Request
Project Name
Council District
Requested by

DTC Modification
Capitol View Signage
19 – O’Connell
Kathryn Withers, with Barge Design Solutions;
Jeff Haynes, with Boyle Investment Company

Downtown Code DRC Meeting of 1/3/2018

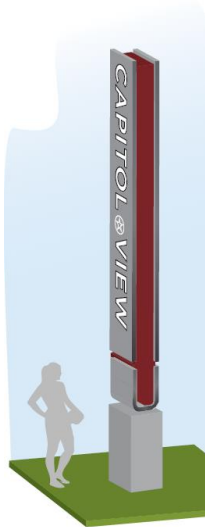
2. A-2: Block E – Triangle Park Feature

- Height
 - Required: 10 ft
 - Proposed: 25 ft
- Depth
 - Required: 18 in
 - Proposed: 38 in
- Illumination:
 - Required: Background must be opaque; only graphics, text and logos may be illuminated.
 - Proposed: To permit accent panels to illuminate

A-1

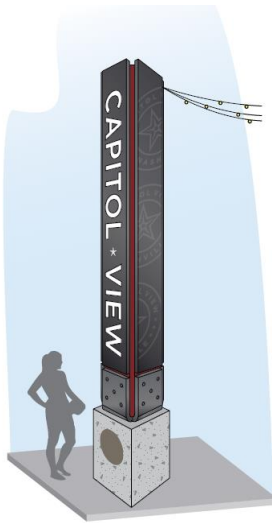
1. A-1: District Main ID Sign

- Height:
 - Required: 15 ft
 - Proposed: 25 ft
- Illumination:
 - Required: Background must be opaque; only graphics, text and logos may be illuminated.
 - Proposed: To permit accent panels on side to illuminate.
